Part Number Update

Bulletin No: PNU-186

Subject: Bendix® Slack Adjuster OEM Replacement Part Numbers Announced

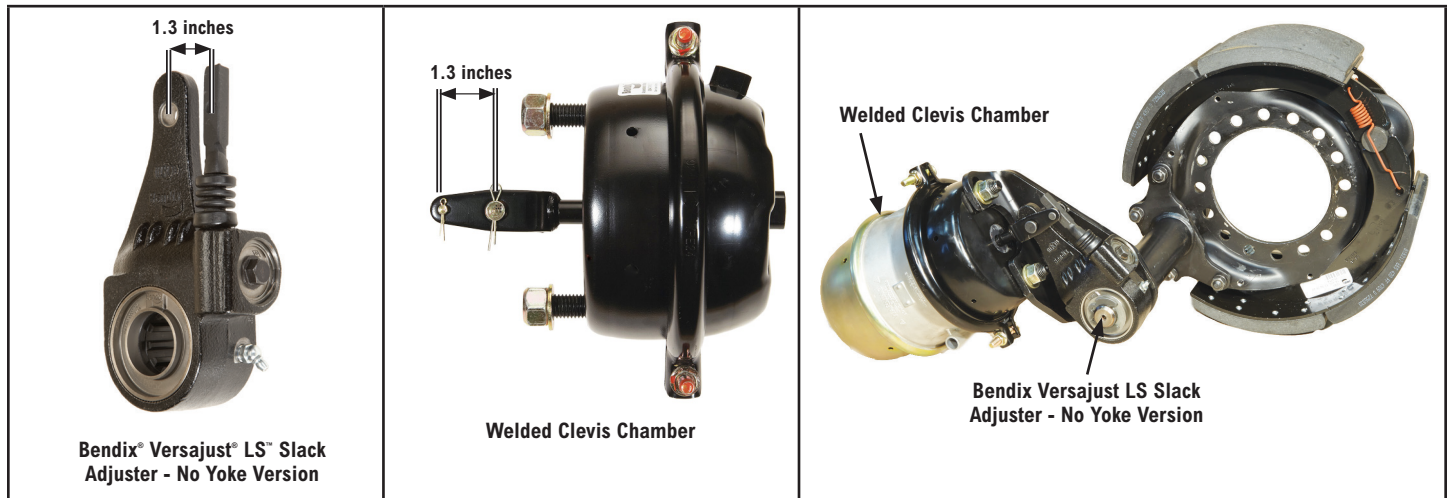
Bendix announces that OEM Bendix® ASA-5® slack adjusters are being obsoleted and will remain active and saleable only while supplies last. Once the inventory is depleted, all orders placed will be filled by the equivalent Bendix® Versajust® LS™ Slack Adjuster with the WearMax™ Clutch. This Bulletin shows the OEM Bendix Versajust LS slack adjuster part number replacements, as well some new OEM Bendix Versajust LS slack adjuster units for use with welded clevis chambers. Please use the new part numbers for future orders.

|  <p>Bendix® ASA-5® Automatic Slack Adjuster Exterior</p> <p>Bendix® Versajust® LS™ Automatic Slack Adjuster Exterior</p> <p>Part Number Etched Here</p> | <p>Bendix Versajust LS Quick-Connect Style Yoke Kit</p>  <p>Adapter Thread</p> <p>Long Pin shown (Short Pin used for welded clevises)</p> |  <p>Yoke 1.3 inches*</p> <p>Arm Length</p> <p>Lube Fitting (0° shown)</p> <p>Spline (Select by diameter and number of teeth)</p> <p>*Note: Pin Centers are 1.3 inches apart for Versajust LS Slack Adjusters - for ASA-5 Slack Adjusters the distance is 1 inch.</p> |
| <p>NOTE: ASA-5 and Versajust LS Slack Adjuster YOKES are NOT INTERCHANGEABLE.</p> | | |

Section A — OE Slack Adjusters WITH Yokes: Bendix® ASA-5® to Bendix® Versajust® LS™ slack adjuster equivalents.

These are for use with welded clevis chambers with 1.3 inch pin-to-pin spacing.
